**U.S. NAVY ARCTIC ICE CAMP
AK0053783**

EPA PROPOSES TO MODIFY A NPDES PERMIT

The EPA proposes to modify the NPDES permit issued to the facility referenced above. The proposed modification includes the following:

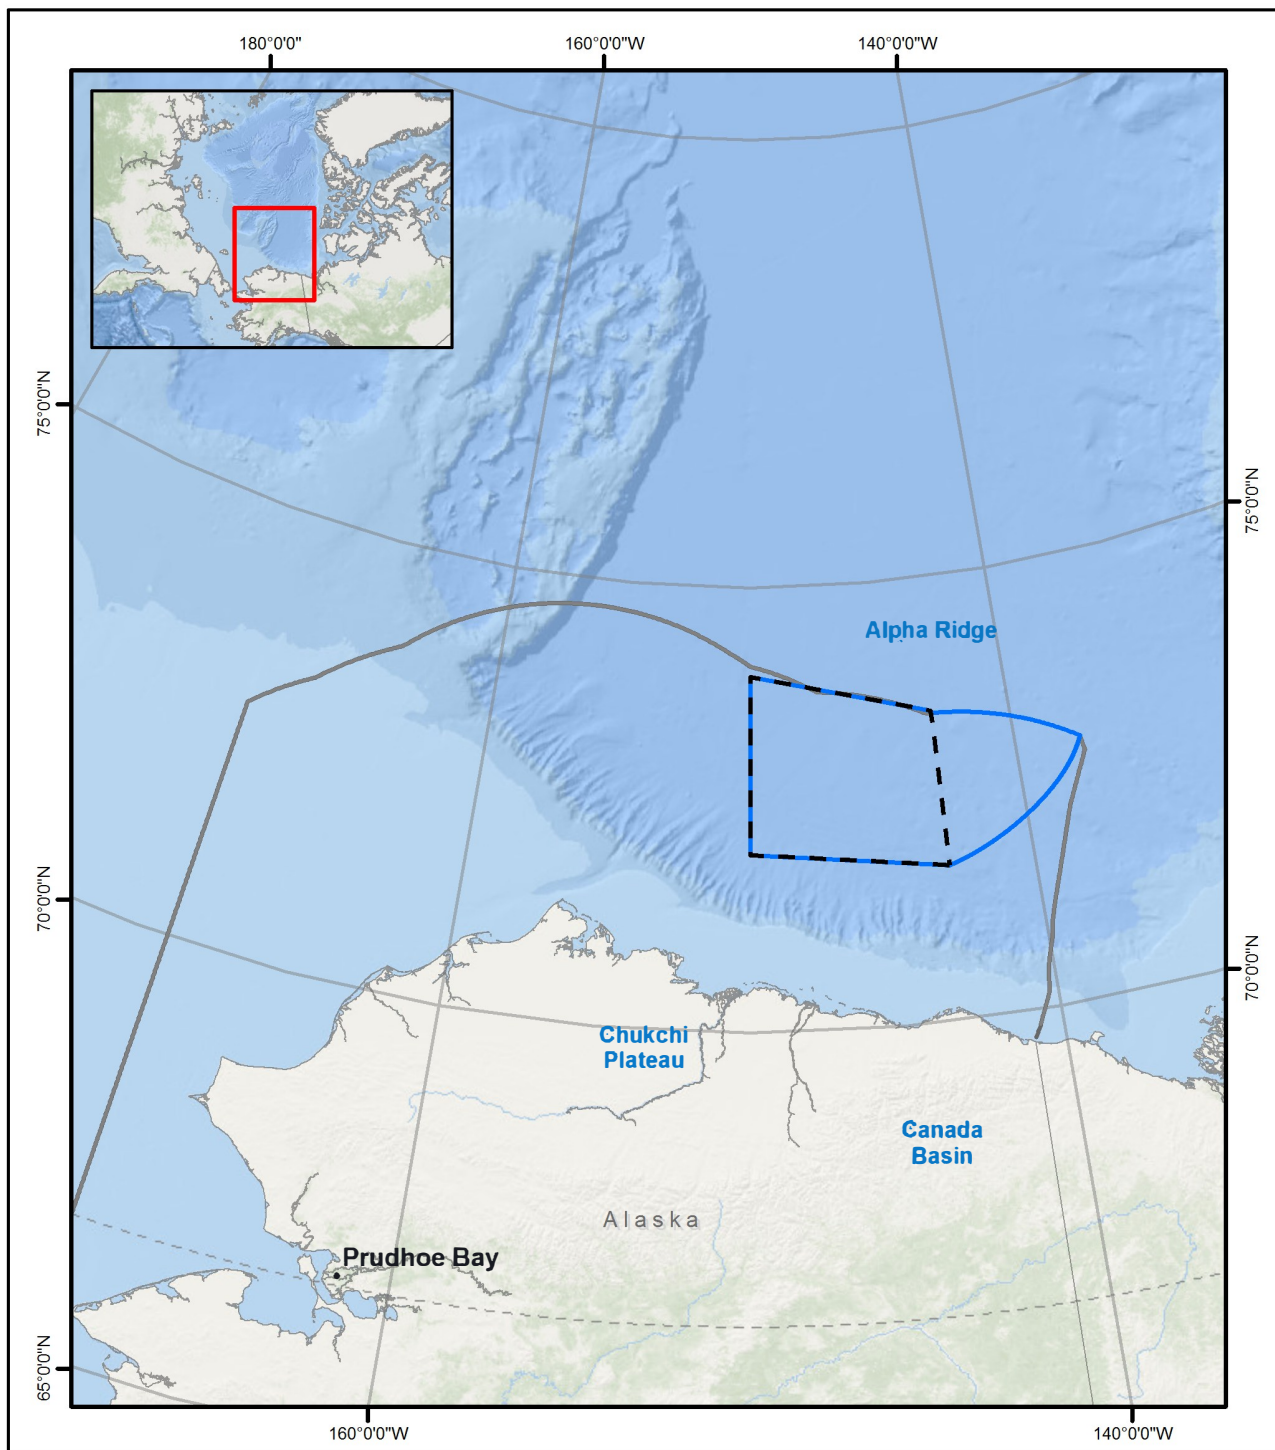
The U.S. Navy operated the Arctic Ice Camp in February 2016 at a location approximately 197 nautical miles north of Deadhorse, Alaska. During this season, ice floe drift was observed to be greater than anticipated and the Arctic Ice Camp moved close to the boundary authorized by the 2015 NPDES permit. To ensure the camp operates within the permitted area, the U.S. Navy requested to expand the area of potential operation where the discharge could occur to the east (M. Geremia, personal communication, July 20, 2017). Figure 1 depicts the current permitted area of operation and the requested expansion.

The EPA is proposing to expand the area of potential camp operations. The area is the specified geographic location in which the U.S. Navy is authorized to discharge graywater (Outfall 001) and reverse osmosis reject water (Outfall 002). The Arctic Ice Camp will still be established on multi-year ice approximately 100 – 200 nautical miles north of Deadhorse, Alaska.
